SUBJECT: VOGTLE ELECTRIC GENERATING PLANT, UNITS 1 AND 2 – ISSUANCE OF AMENDMENTS REGARDING NUCLEAR SERVICE COOLING WATER FAN OPERATION (TAC NOS. ME7105 AND ME7106)

Amendment No. 170  
Renewed License No. NPF-68

Amendment No. 152  
Renewed License No. NPF-81

SAFETY EVALUATION BY THE OFFICE OF NUCLEAR REACTOR REGULATION

Figure 3.7.9-1  
Required Number of Fans/Spray Cells

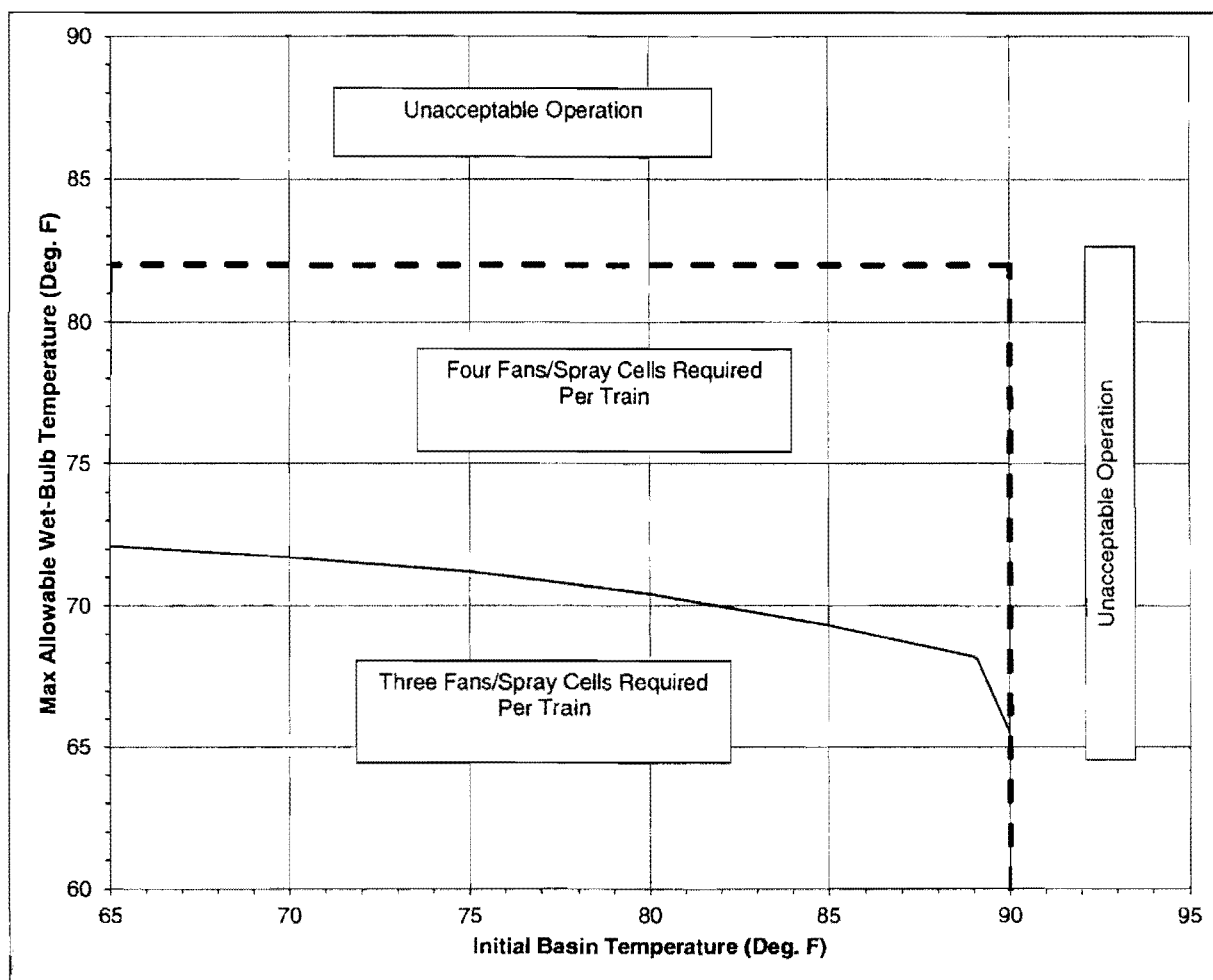
The LCO is revised to state, "The UHS shall be OPERABLE. The fans/spray cells shall be as specified in Figure 3.7.9-1." This proposed change is the result of revised engineering calculations. Associated with the revised LCO, surveillance SR 3.7.9.5 is to be changed to verify wet bulb temperature is within the three-fan/spray cell region of TS Figure 3.7.9-1 if 1 NSCW tower fan is out of service and the daily high dry bulb temperature is expected to be >48 °F.

The subject of the second change is to add a new Condition B that allows a 7-day CT if one-fan/spray cell is inoperable, only when operating in the four-fan/spray cell required region of proposed TS Figure 3.7.9-1. Other changes consist of alphanumeric changes, such as current TS Condition B being changed to Condition C, and other formatting changes required due to the changes discussed above.

Since the maximum initial basin temperature for a given wet bulb ambient temperature to be used in establishing the LCO must meet the acceptance criteria in both the DBA [LOCA with LOSP] and the tornado induced LOSP as shown in the tables above, the most limiting initial basin temperature should be used to establish TS LCO limits. Those limits are represented by the licensee’s Figure 3.7.9-1 in their June 14, 2013 letter. Figure 3.7.9-1 combines the results of the design basis calculations for DBA-LOCA and the design basis event (DBE) (tornado induced LOSP and tornado missile strike), i.e., the operating limits for LCO 3.7.9 and its Figure 3.7.9-1 are based on the cases for (a) the worst case LOCA and (b) a LOSP event in conjunction with tornado generated missiles. The combined curve with the most limiting values defines the required number of fans/spray cells for the LCO to prevent basin temperature from exceeding its limit for either a DBA-LOCA or tornado induced LOSP. The revisions in the proposed LCO meet the requirements of GDC 2 and GDC 44 and the guidelines of RG 1.27. In accordance with 10 CFR 50.36, LCO limits for temperature have been established for the UHS basin which supplies NSCW cooling to safety-related components that are essential to mitigate the DBA-LOCA and a tornado induced LOSP.

The NRC staff evaluated the LAR where the subject of the second change is to add a new Condition B that allows a 7-day CT if one fan/spray cell is inoperable, only when operating in the four-fan/spray cell required region of proposed TS Figure 3.7.9-1. The existing TS do not allow a required fan to be inoperable for more than 72 hours before action is required to commence shutdown. The subject of the LAR is to add a new Condition B that allows a seven-day CT if one fan/spray cell is inoperable, only when operating in the four-fan/spray cell required region of proposed TS Figure 3.7.9-1. The licensee has stated that repair of NSCW fans challenges the current 72-hour CT. Fan maintenance often requires staging and crane service possibly in inclement weather. Repair efforts in the past have challenged the current 72-hour CT. The licensee has taken steps to avoid unplanned maintenance by enhanced preventive maintenance including a) replacing gearbox oil and inspecting output shafts for backlash, b) replacing fan gearboxes based on runtime, c) installation of vibration monitoring equipment for early warning. The licensee has proposed compensatory measures to be in effect before Condition B is entered. The compensatory measures include:

The required numbers of fans/spray cells are a function of initial basin temperature and the maximum allowable ambient wet bulb temperature and are specified in Figure 3.7.9-1. The staff finds the limits specified in the new Figure 3.7.9-1 to be acceptable. The staff has also reviewed the licensee's proposal to extend the CT of one inoperable fan from 72-hours to 7-days when operating in the four-fan region of new Figure 3.7.9-1. Based on the licensee's compensatory actions specified in the technical evaluation above, the low probability of a DBA during the extended CT, and the moderate increase in basin temperature, the staff finds the licensee's proposed increase in CT identified in new Condition B to be acceptable.

LCO 3.7.9 The UHS shall be OPERABLE. The fans/spray cells shall be as specified in Figure 3.7.9-1.

| CONDITION  | REQUIRED ACTION   | COMPLETION TIME |
|--|---|-----------------|
| B. One NSCW cooling tower with one required fan/spray cell inoperable when operating in four fan/spray cell required region of Figure 3.7.9-1. | B.1 Restore fan to OPERABLE status.                                   | 7 days          |

| SURVEILLANCE |   | FREQUENCY   |
|--------------|---|---|
| SR 3.7.9.5   | Verify ambient wet-bulb temperature is within the three fan/spray cell region of Figure 3.7.9-1 when one NSCW tower fan/spray cell is out-of-service and daily high temperature (dry-bulb) is forecasted to be $> 48^{\circ}\text{F}$ . | In accordance with the Surveillance Frequency Control Program |
